RE: Construction of the Perimeter Groundwater Containment System  
American Chemical Service, Inc. Superfund Site  
Griffith, Indiana

## PROPOSAL TO MODIFY THE GROUNDWATER EXTRACTION TRENCH PERIMETER GROUNDWATER COLLECTION (PGCS) SYSTEM ACS NPL SITE RD/RA

FIGURE 4. Modeled Plume Capture by the Extraction Trench in the PGCS 50 Percent Design

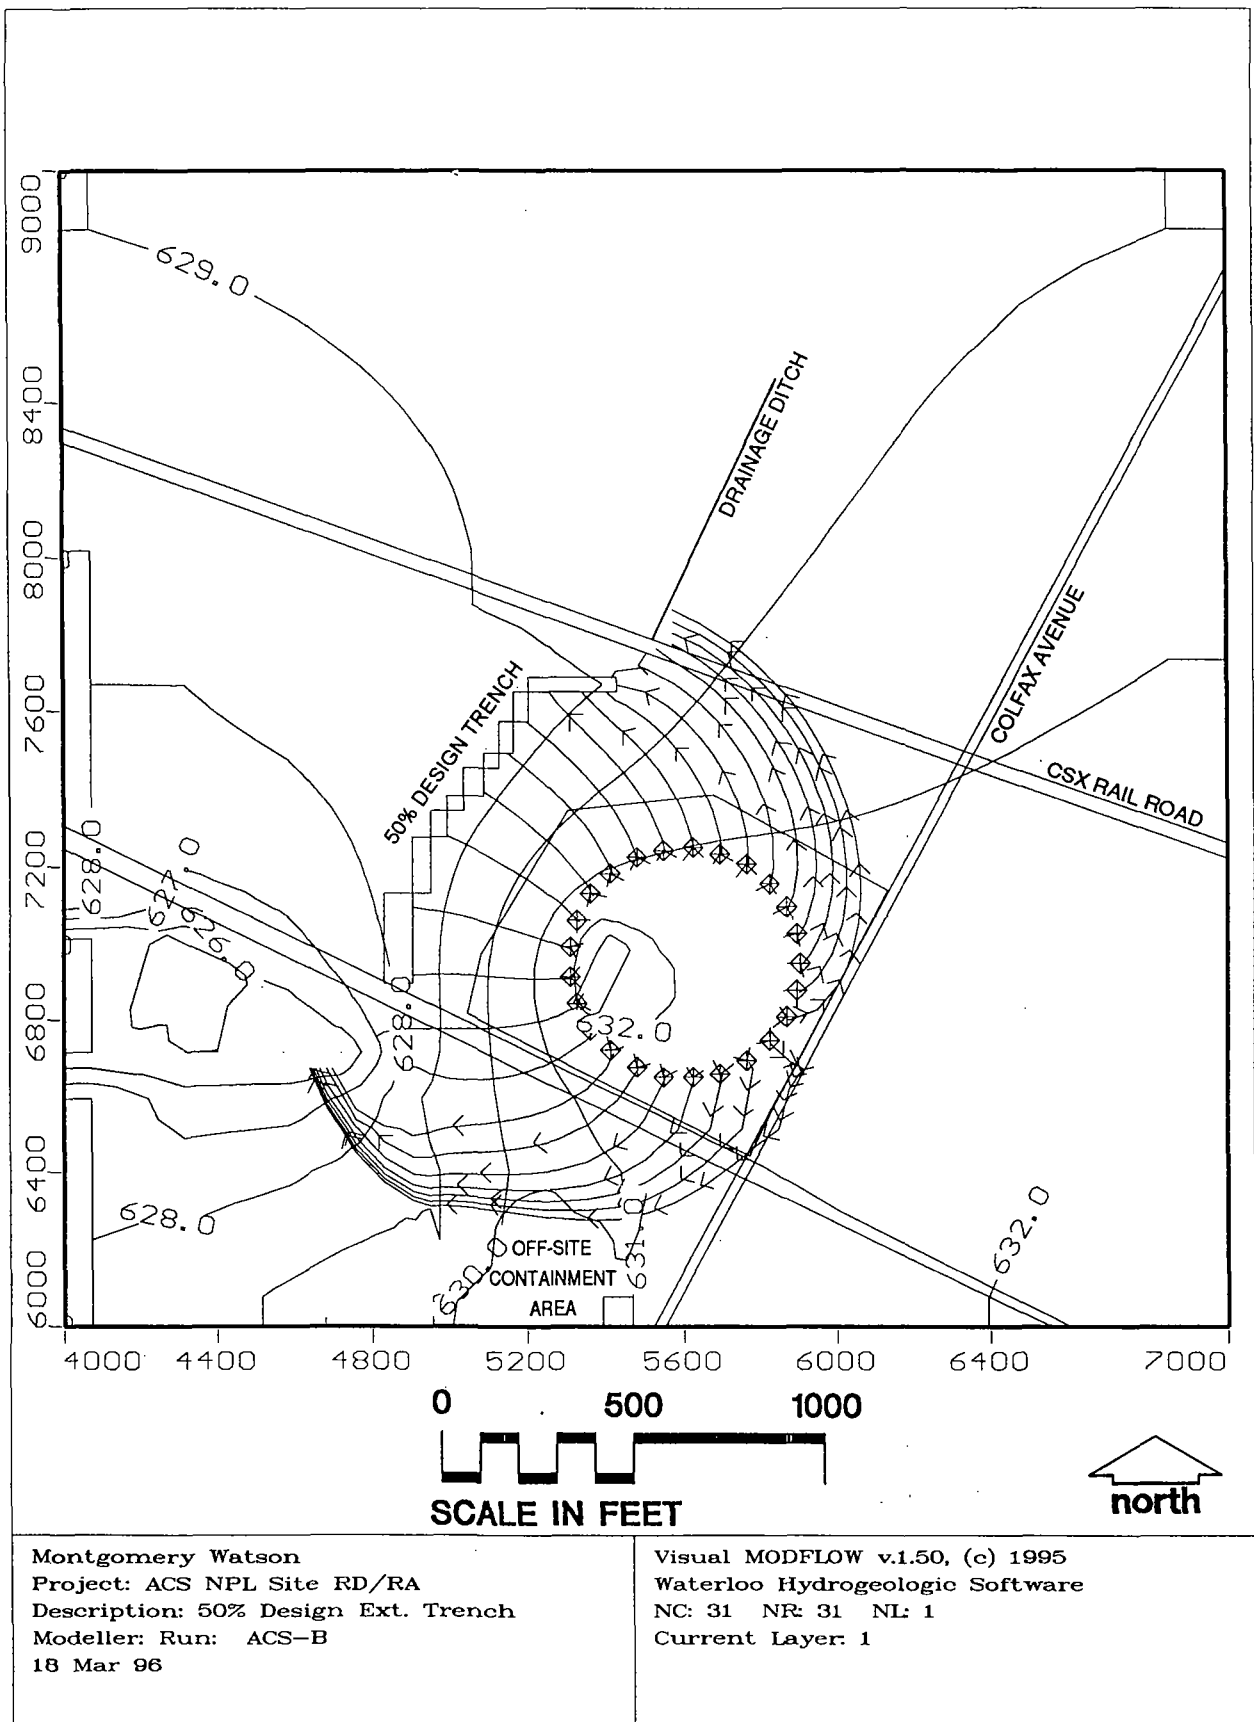
The second model run was implemented to evaluate the potential effectiveness of the extraction trench as it was conceived in the 50 Percent Design document. It is evident from the pathlines, that the extraction trench will be effective in capturing the contaminant westward and northwestward from the ACS facility. However, the VOC plume migrating to the north, still extends to the ditch, north of the railroad tracks. Therefore, the extraction trench must be lengthened to the east to capture the plume migration to the north.

FIGURE 5. Modeled Plume Capture by the Extended Extraction Trench

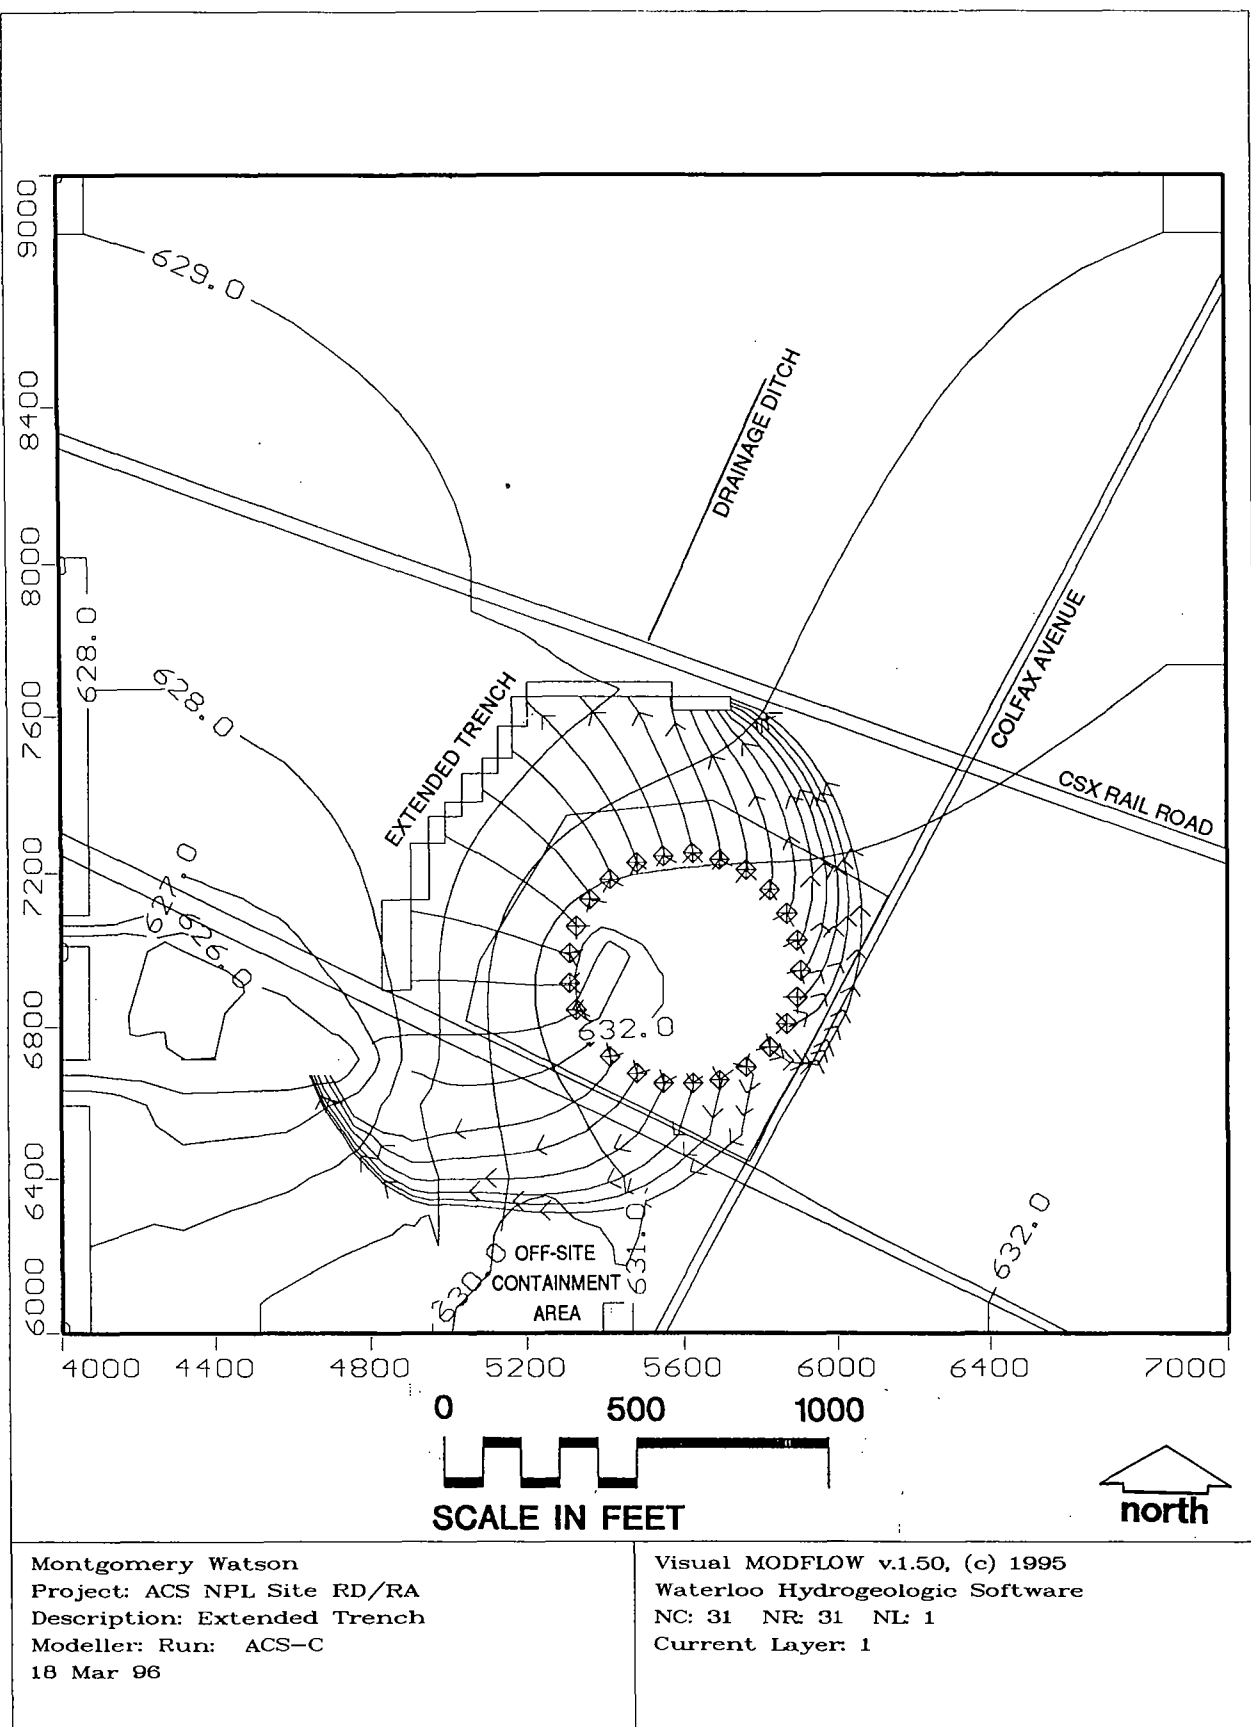
Several different trench configurations were evaluated. Model run “ACS-C” is the model run in which the extraction trench was extended an additional 300 feet to the east. The plot of contour lines and particle tracks (Figure 5) shows that this will be sufficient to prevent the off site migration of contaminants in the upper aquifer. The flow paths are cut off and do not extend north of the CSX railroad tracks.

The results of this analysis and modeling show that extending the groundwater extraction trench 300 feet farther to the east than planned in the 50 Percent Design, will be sufficient to establish and maintain hydraulic control of the upper aquifer on the ACS Site and prevent off-site migration of the contaminants. This conclusion will be field verified with piezometers and monitoring wells following system startup.
